TREMONT STREET DRAINAGE IMPROVEMENTS

PROJECT NO. 68905 / STP-0904(3)

Project As-Built Drawings have been reviewed by the Project Engineer and represent to the best of my knowledge, the project as constructed.
PE Sevard W. Date 7-15-11

TYPICAL BURIED WATER SERVICE - 2" AND SMALLER

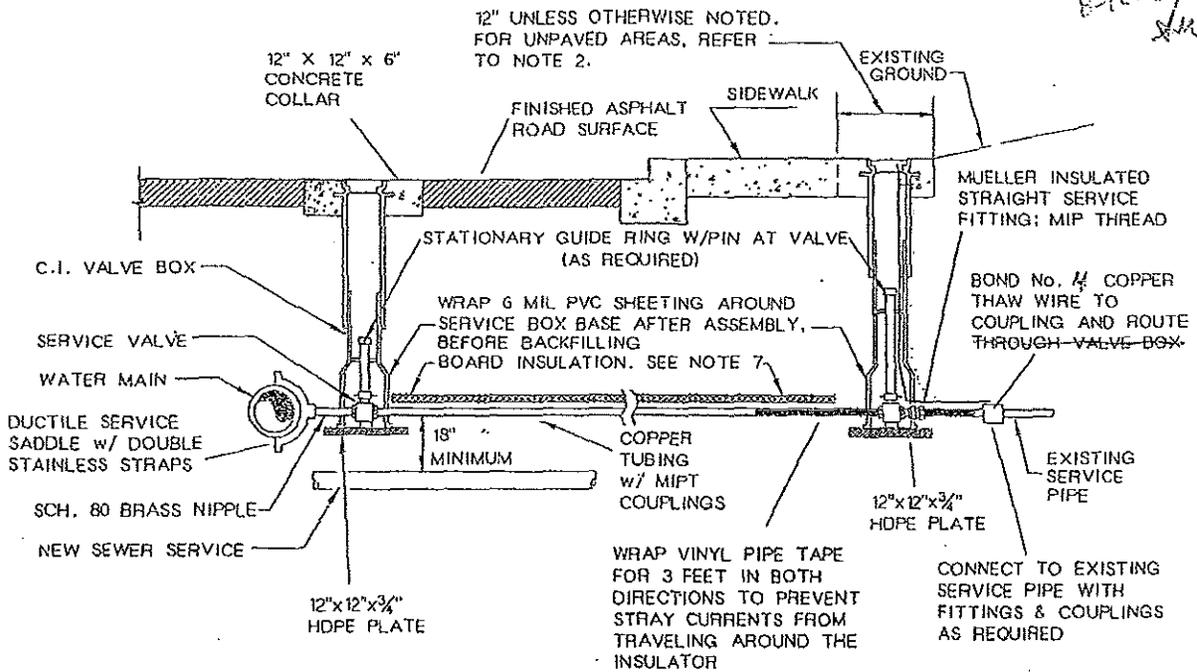
Water Service installed per City Drawing of RPK

SEWER LATERAL PROFILE

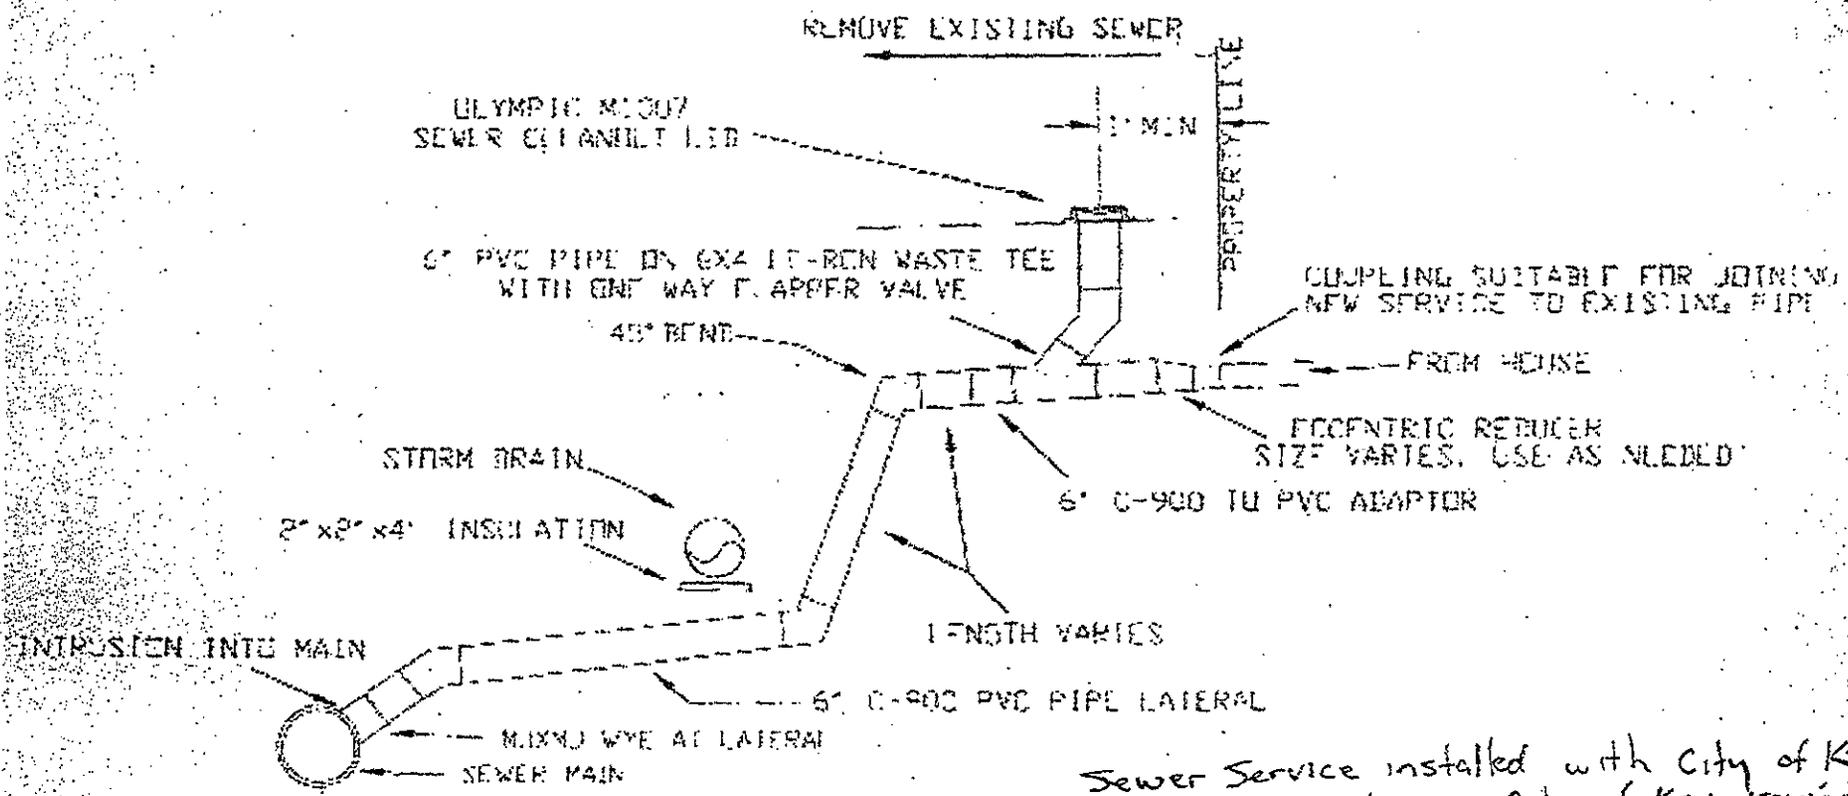
Sewer Service installed with City of Ketchikan
 supplied materials per City of Ketchikan drawing

END DRAIN INLET SECTION (C F1)
(1 REQ'D)

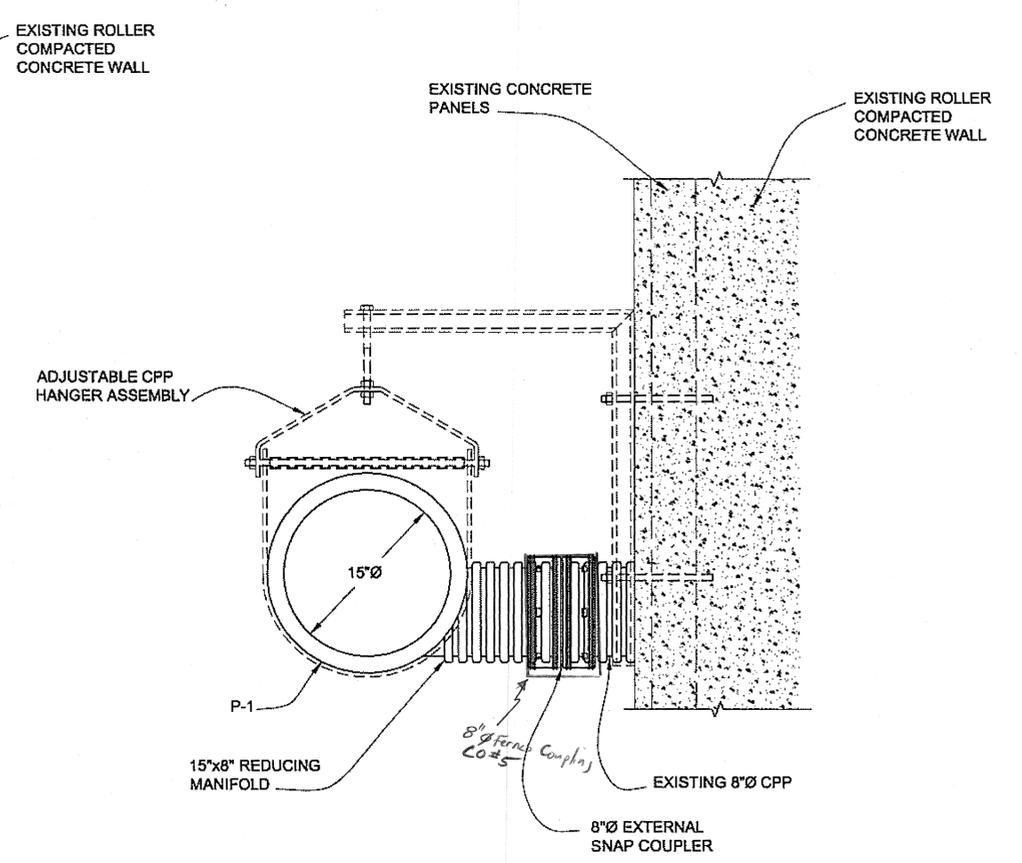
CO#5 - Add Fernco Couplings at all 6\"/>

TIMBER STAIRWAY DETAILS

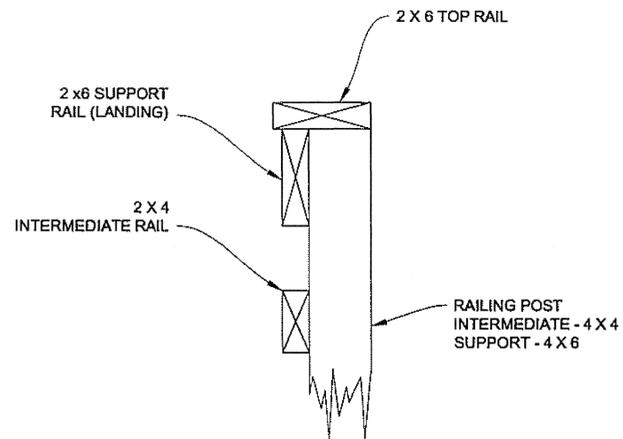
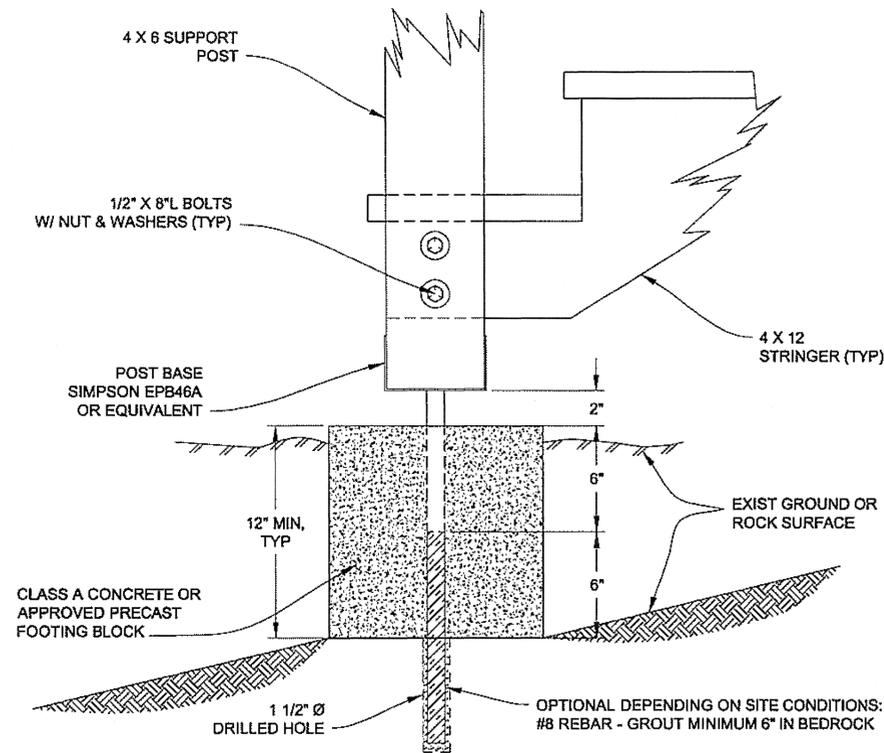
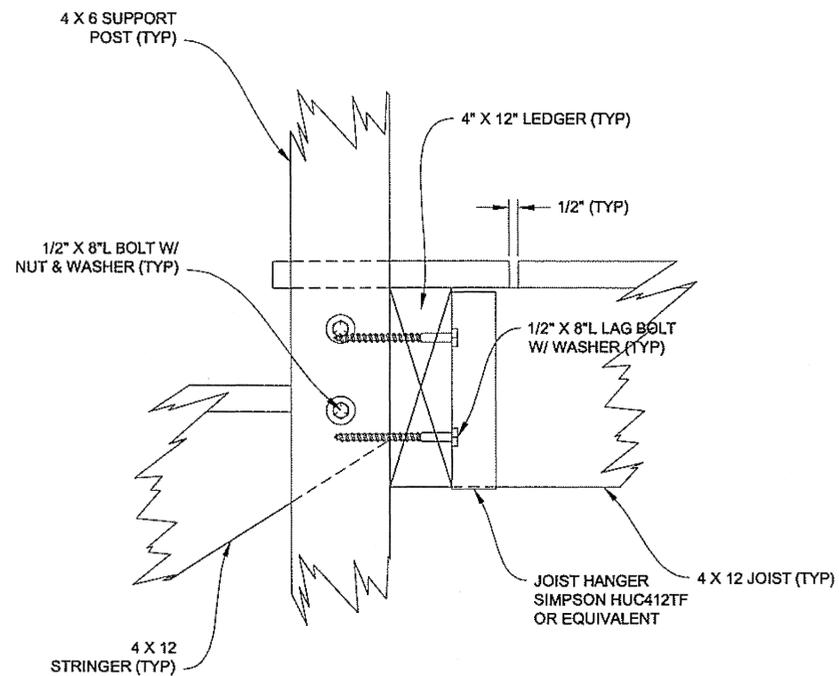
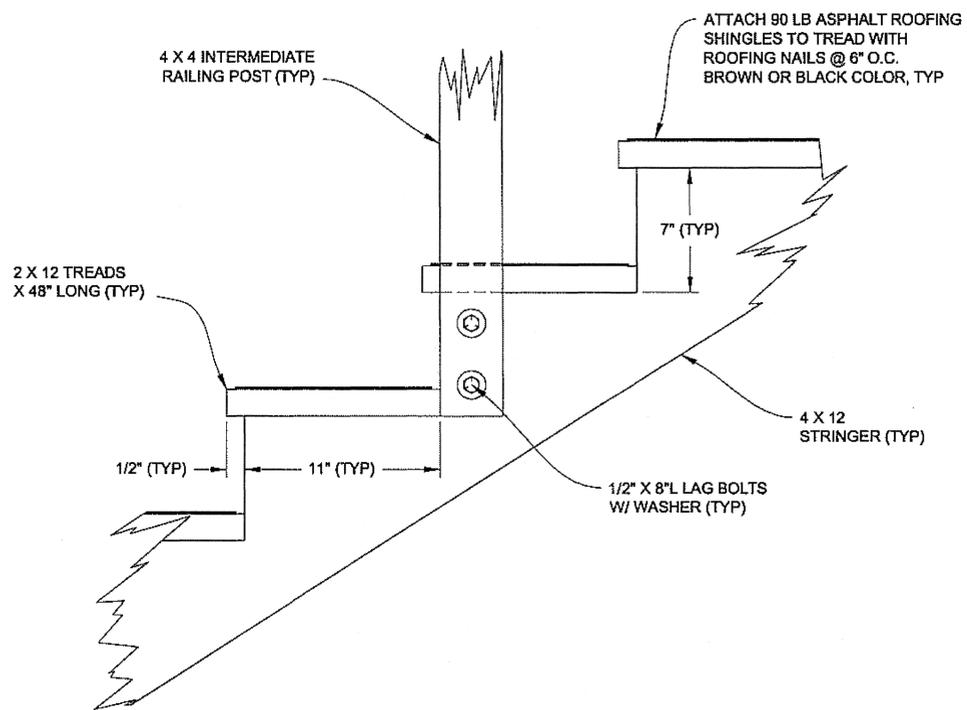
8. WHERE "H" EXCEEDS 8-FEET, USE TWO PANELS OF CROSS BRACING.
9. *Co#5 Remove/Replace Entire Boardwalk*
